Structures Engineering Instructions (SEI)

Subject: Northeast Extreme Tee Beams

Cracking in flange and web section of NEXT F Beams

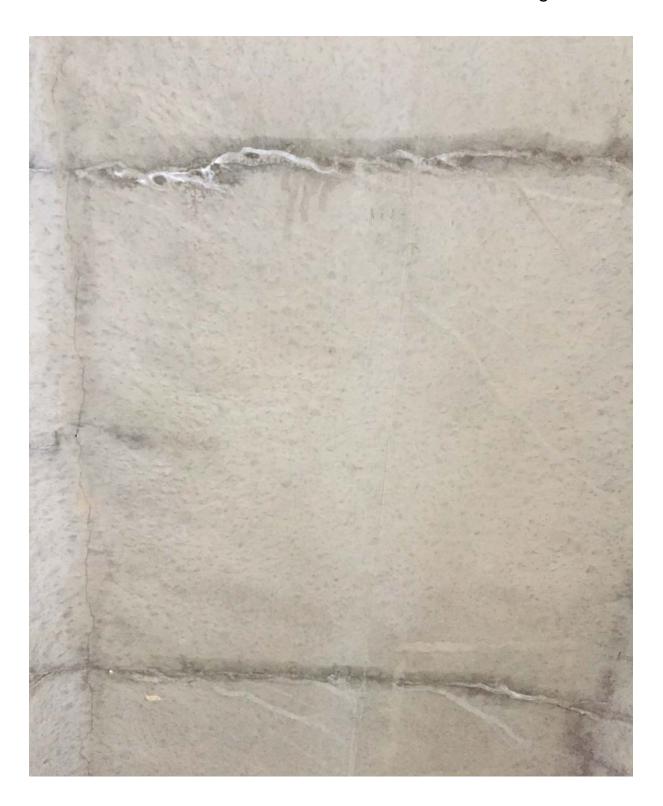
Significant cracking has been observed in prestressed concrete Northeast Extreme Tee Form (NEXT F) beams on a recent project that can be seen in the attached photos. VTrans will continue evaluation and research into the cracking.

Transverse cracking in NEXT F flange and cracking along the flange to web transition.

Cracking in NEXT F Section that was repaired at the Fabrication Plant but has opened back up.

Pending the completion of the research, prestressed NEXT F Beams and NEXT E Beams shall not be specified for VTrans bridge projects under design.
